**RESOLUTION SETTING HEARING ON REQUEST FROM  
M & R HOLDINGS, LLC FOR REVIEW AND APPROVAL OF THE 1<sup>ST</sup> AMENDMENT  
TO THE WOODLAWN PUD CONCEPTUAL PLAN FOR PROPERTY LOCATED AT  
4209 LOWER BEAVER ROAD**

## **STAFF REPORT TO THE PLANNING COMMISSION**

# WOODLAWN 1ST AMENDMENT PLANNED UNIT DEVELOPMENT

PUD LAYOUT

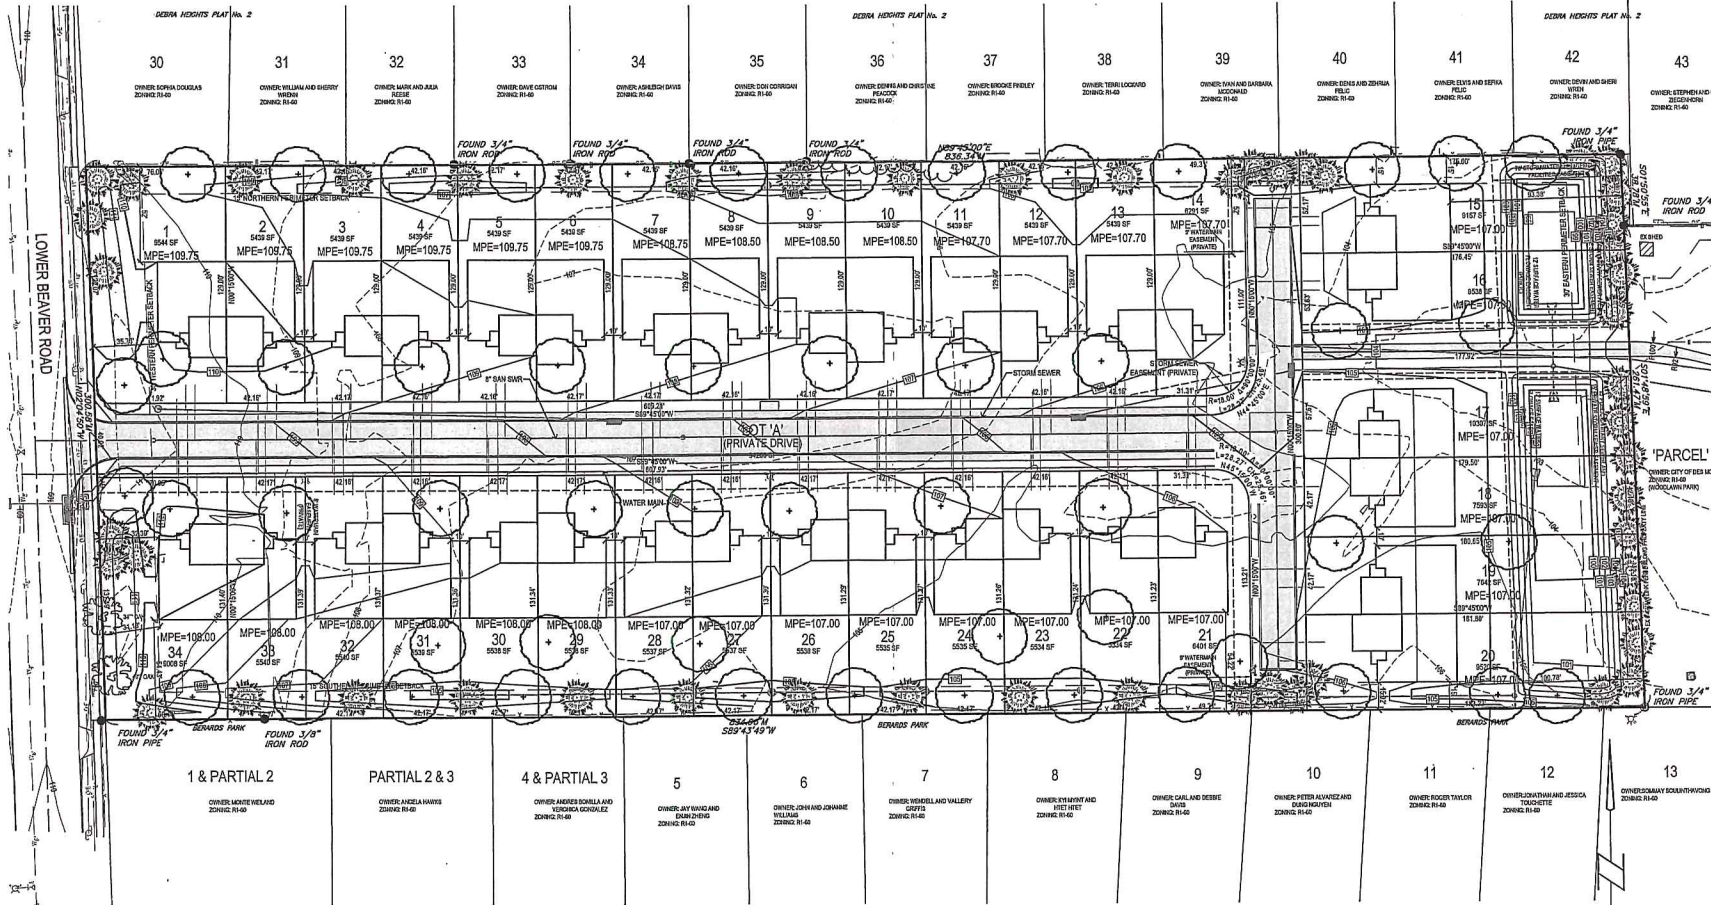
4. **Landscaping & Buffering:** The previously approved and proposed PUD Conceptual Plans indicate a requirement to meet an established Open Space and Bufferyard requirement. This would require 2 over story trees and 2 evergreen trees per 100 feet along the perimeter yards adjoining residential properties as part of any Development Plan. It also required 1 over story tree, one evergreen tree, and one shrub per 2,500 square feet of a minimum 20% of open space. In order to accommodate adjoining neighbor concerns, the developer has concentrated the tree planting concept to the perimeter of the development. The previously approved PUD Conceptual Plan included a 6-foot tall wood privacy fence around the perimeter of the development. The amendment does not propose a privacy fence. Staff would recommend that the plans be revised to include a privacy fence based on previous neighborhood concerns.

6. **Traffic/Street System:** The submitted PUD Conceptual Plan amendment and Preliminary Plat/PUD Development Plans reflect an alignment of the private drive location that was adjusted based on the conditions of the previous approvals. This balanced out rear yard setbacks to both the north and south. Additionally, the required integral 4-foot pedestrian walks on either side of the drive are still proposed. The number of proposed units is below the threshold for requiring an in depth Traffic Analysis as it would not generate more than 50 trips during any peak hour. One comment from Traffic Engineering in response to the submitted PUD Conceptual Plan amendment is that there is no separate parking areas designated for visitors and that this should be considered given that parking will not be permitted along the private drive as it must be kept open for fire access.

7. **Fire Access:** The approved PUD Conceptual Plan requires that any number of residential units built in excess of 30 units shall have approval by the Fire Marshal under alternate design or with an approved secondary access drive. The submitted PUD Conceptual Plan amendment proposes to fire sprinkler the number of units (4) over 30 units which are furthest away from the drive entrance to Lower Beaver Road. The Fire Prevention Engineer has commented on the submitted PUD Conceptual Plan amendment that all the units would need to be sprinkled in order to meet and alternate design without a secondary fire access.

The submitted elevations generally comply with these requirements. Additionally, the rear setbacks of the proposed units are 50 feet from property line, while the previously approved setbacks were 40 feet from property line, irrespective of decks. The primary option proposed for the units would be the elevation required along the Lower Beaver Road frontages.

In the previously approved PUD Conceptual Plan, the City Council allowed for use of Vinyl siding material since they were two-family. The submitted design elevations do not propose any Vinyl material. Staff recommends that the allowance for that material be stricken from the Architectural Standards with any approval of a PUD Conceptual Plan amendment.

Staff is also concerned about proposal to reduce the variety in the number of dwelling unit types. This is the primary reason a PUD Conceptual Plan amendment was not considered administratively. Staff believes that while the developer is not able to use the previously approved three design types, that an equivalent number of types should be offered at a minimum by the developer to maintain the original intent of the PUD Conceptual Plan approval.

1. Revision of the Conceptual Plan amendment to provide a 6-foot wooden opaque fence along the north and south property lines.
2. Remove the reference to allow Vinyl in the Architectural Standards.
3. Consider provision of separate visitor parking with any Preliminary Plat/PUD Development Plan.
4. Revision of the PUD Conceptual Plan notes to indicate compliance with the Fire Code for provision of secondary access or alternate design approval by the Fire Department.
5. Prior to submission of the PUD Development Plan the developer shall have a neighborhood meeting to review the PUD Development Plan and building plans.
6. No additional driveways on Lower Beaver Road.

7. Provide some enhanced landscaping on Lower Beaver Road frontage.
8. To provide at least two different unit types beyond elevational changes.
9. No reduction in the backyard current setback less than the presented 50 feet minimum.
